MALMESBURY AND ST PAUL MALMESBURY WITHOUT: PROPOSED WAITING RESTRICTIONS

RECOMMENDATIONS FOR AMENDMENTS TO PROPOSALS

St Johns Street

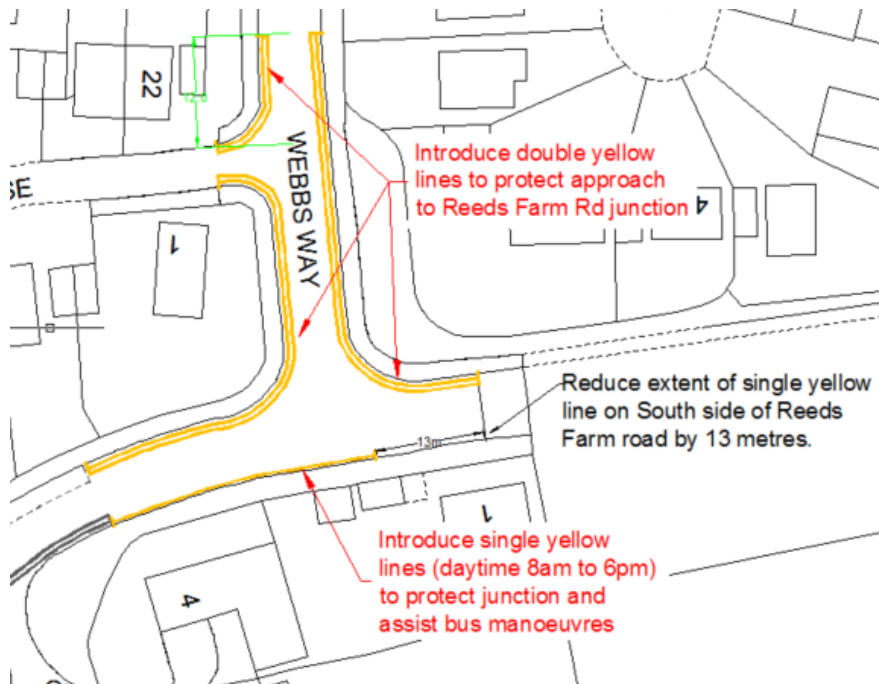
The proposed double yellow lines will only run up 1 metre in a northerly direction rather than the 5 metres previously advertised.

Reeds Farm Road

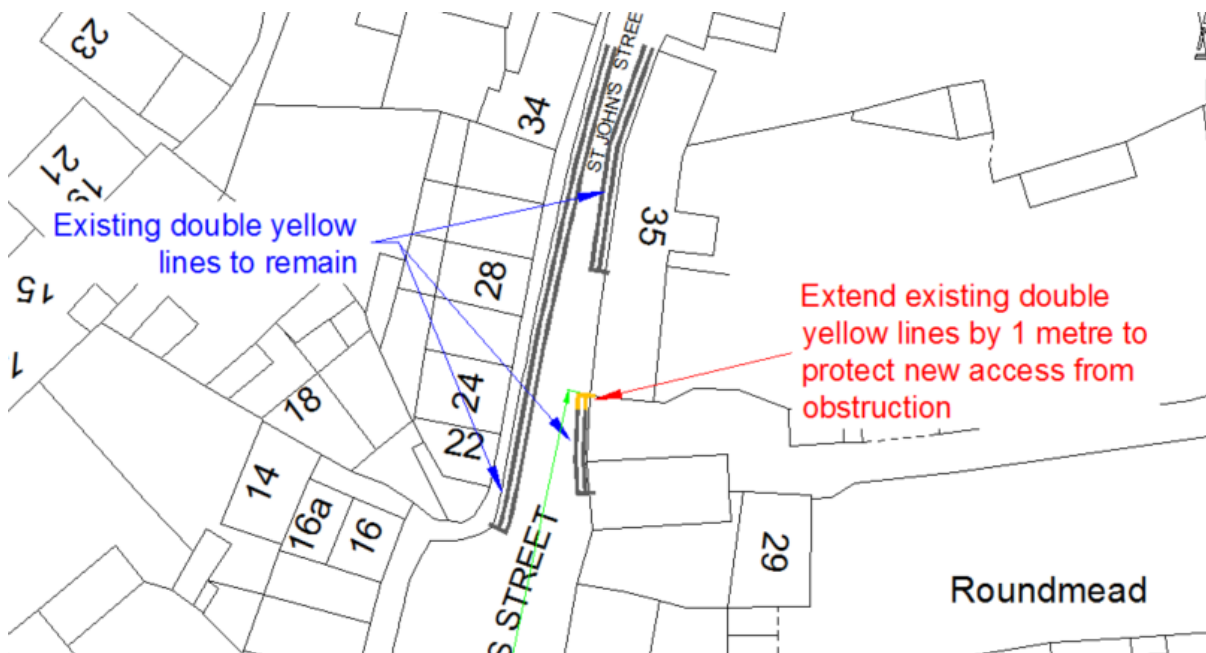
Reduce the extent of SYL to the south of Reeds Farm Road by 13 metres to protect accesses. This reduction is not expected to affect the visibility of the junction as the road acts like a bend with a dead end to the east of the road.
